# MEETING AGENDA

## Appearance Commission

April 02, 2026

A. **Public Meeting** for Case 26-10: Comprehensive Sign Plan for Dobbs Tire and Auto Center at 18340 Kedzie Avenue

**18" - CAS-44 Non-illuminated HDU Letters - 44 sq. ft.**

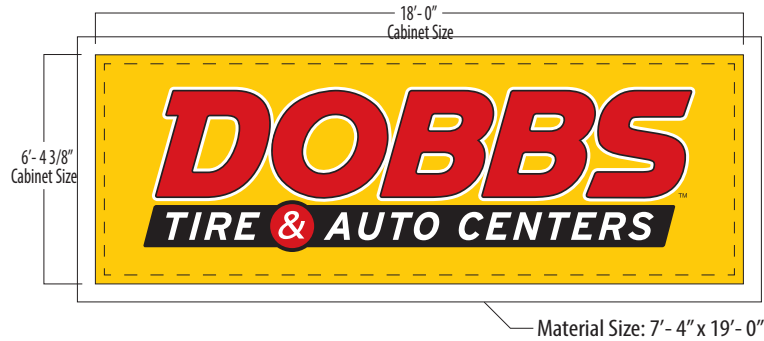
Only one wall sign is permitted per tenant for buildings within the B-3 General Business zoning district. If both signs were proposed as a single sign, the sign would fit within the size allowance for the front façade of this building (127 square feet allowed). A comprehensive sign plan modification is required to allow the second wall sign at this location.

The comprehensive sign plan would allow only one (1) illuminated wall sign, with the additional wall sign required to remain unilluminated. The plan would limit the size of each wall sign on the building to 44 square feet. The plan limits the total number of wall signs to two (2) signs.

**PROPOSED WEST ELEVATION**

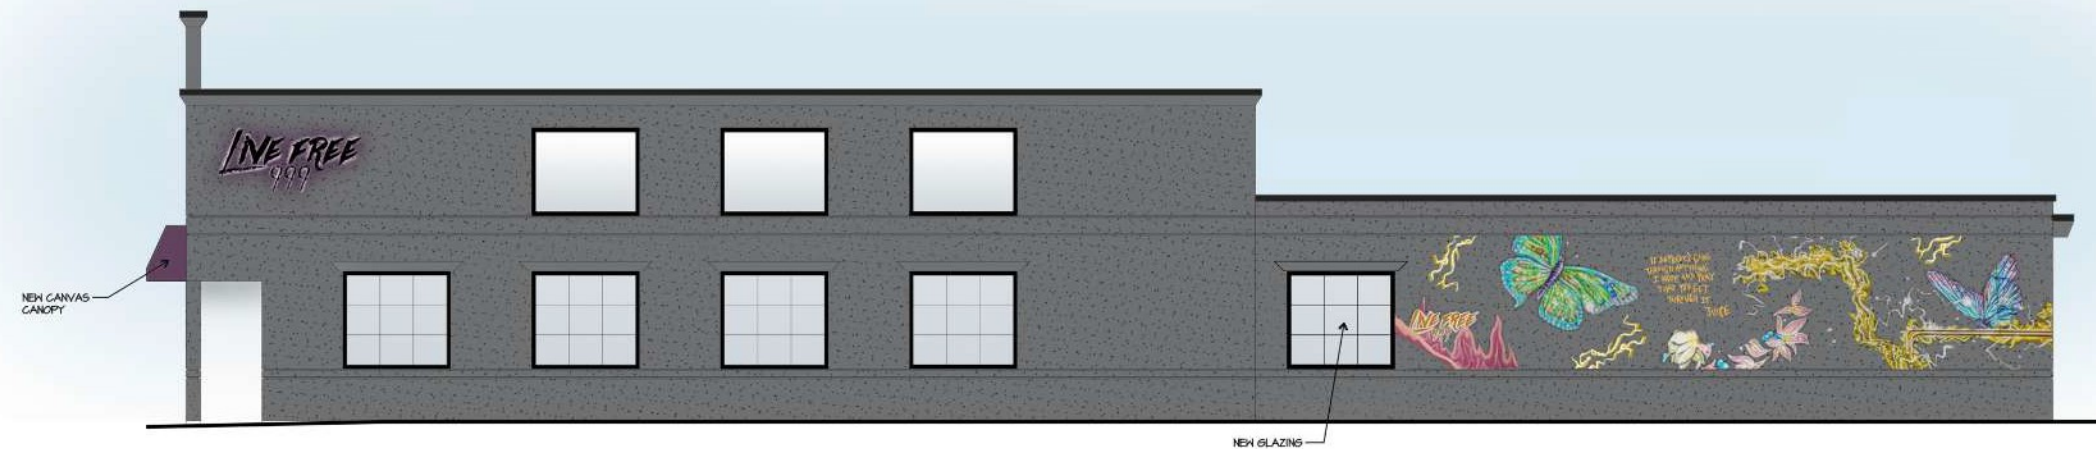
The proposed renovation will create minor structural changes to the building. The applicant will add a window to the south side of the building and a new awning structure will be built on the front of the building. The window will have a dimensions which match the other large windows on the south façade of the first floor, and a window head and pane structure which will match those found on the existing windows on the building. The upper windows of the building are currently blacked out, but these windows will be opened and used to bring additional daylight into the interior of the building.

- Maintain the existing sconce lighting on the south façade, located in the rear 40' of the building, to ensure sufficient alley lighting and nighttime lighting of the proposed painted wall sign. Revise drawings to include lighting prior to the issuance of building permits.

1. Maintain the existing scone lighting on the south façade, located in the rear 40’ of the building, to ensure sufficient alley lighting and nighttime lighting of the proposed painted wall sign. Revise drawings to include lighting prior to the issuance of building permits.
2. Receive Village Board approval for the removal and relocation for the mural on the south façade of the building prior to the issuance of building permits.

SHEET NUMBER  
**A-1.1**

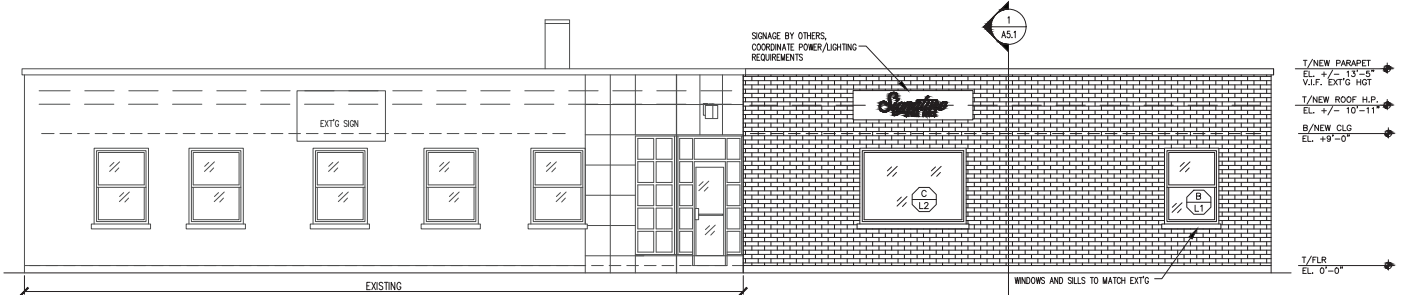
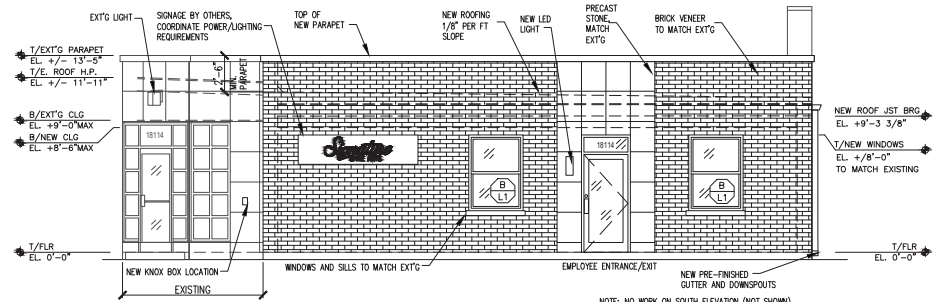
The new building will have a large picture window facing Gottschalk Avenue, which will replace the existing picture window facing north which will be removed with the building expansion. Three other single-hung windows installed in the north and east elevations of the building will mimic the single-hung windows installed in the existing building and provide windows in new offices constructed in the expanded building. New windows will also be installed in the west elevation of the building; however, these windows will be transom windows elevated to 6' above the ground to improve privacy in dental procedure rooms.

The applicant has provided a design where 29% of the length of the façade has transparent openings, including a large picture window and an office window. Due to the presence of private offices along this wall of the building, there are limited opportunities to add additional transparency along this side of the building.

4. Add an additional shielded security lighting fixture at the northwest corner of the building on the west façade, matching the existing security lighting fixture at the southwest corner of the building on the west façade, to ensure sufficient security lighting on this side of the building.

1. Director of economic and community development shall provide a waiver of the transparency requirements for the building as permitted in Section 44-05-11.(d) of the Village Zoning Ordinance.

5. Director of economic and community development shall provide a waiver of the transparency requirements for the building as permitted in Section 44-05-11.(d) of the Village Zoning Ordinance.
